December 2010

## North Sydney Zone Substation Redevelopment Preferred Project Report

**Document:** North Sydney Zone Substation Redevelopment Preferred Project Report  
**Ref:** 60100174  
**Date:** December 2010  
**Prepared by:** Fiona Pennington, Deborah Bowden  
**Reviewed by:** Catherine Brady, Phil Gates, Phil Bratby, Kirsten Evans

**Figure 1 – Proposed Winten and Castle Approved DA Building Profiles with Proposed Substation Profile**

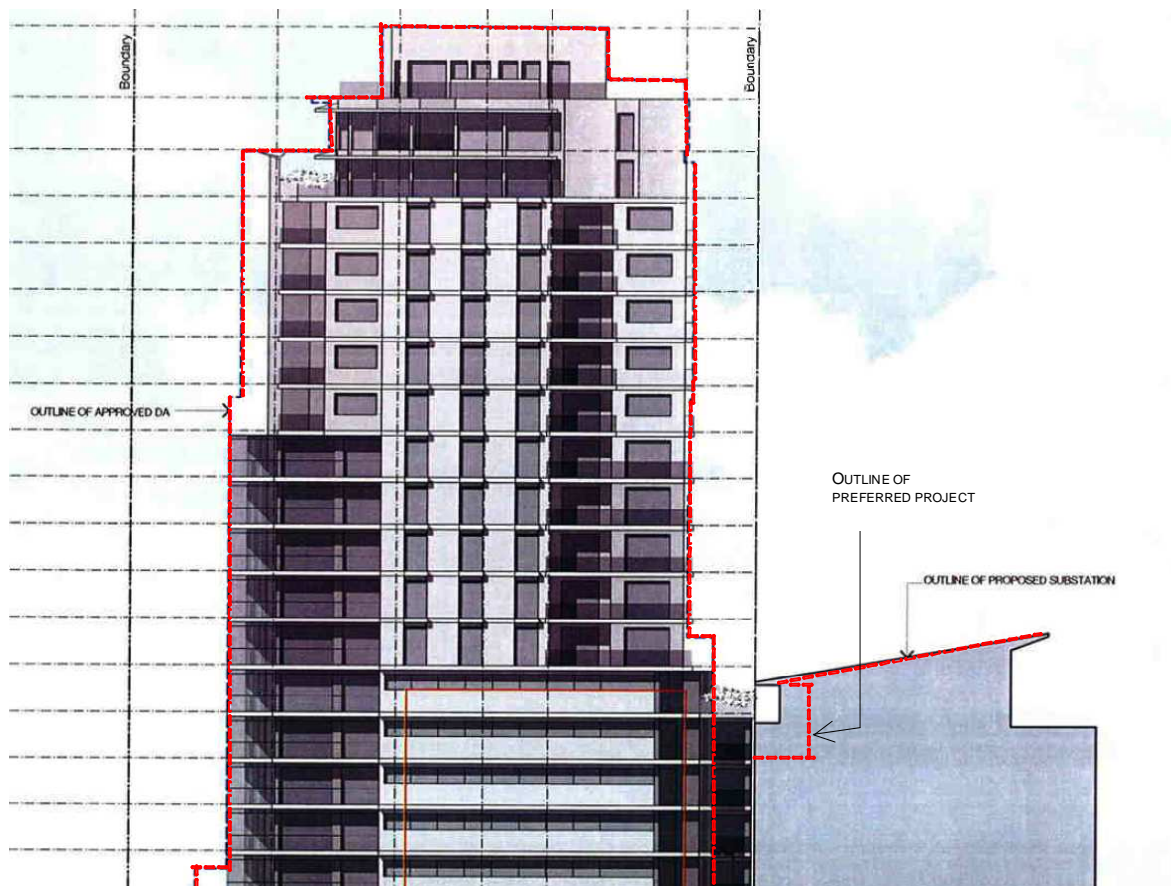
Figure 1 below presents the proposed profile of the Winten Property Group development. The red dotted line around the profile denotes the outline of the Castle Constructions approved development. This profile drawing is an adaptation of a drawing included in the Winten Property Group DA (a copy is included in the submissions presented as Appendix E). The drawing shows the envelope of the proposed substation as presented in the EA and the building envelope of the preferred project is shown by a red dotted line (refer drawings in Appendix A).

The figure illustrates that the profile for the Castle Constructions and Winten Property Group developments are virtually the same with respect to distance from the noise sources associated with the operation of the substation (i.e. on the western side of the substation furthest from the developments).

The main operational noise emission sources from the proposed substation are the transformers which are located in the basement (and the riser to the east of the substation as shown in Figure 1) and fan exhaust and intake which are located on the roof.

Figure 1 shows that the proposed Castle Constructions and Winten Property Group developments are almost in line with one another. For this reason, the operational noise assessment undertaken for the EA would continue to apply for the Winten Property Group development with no increased acoustic impact.
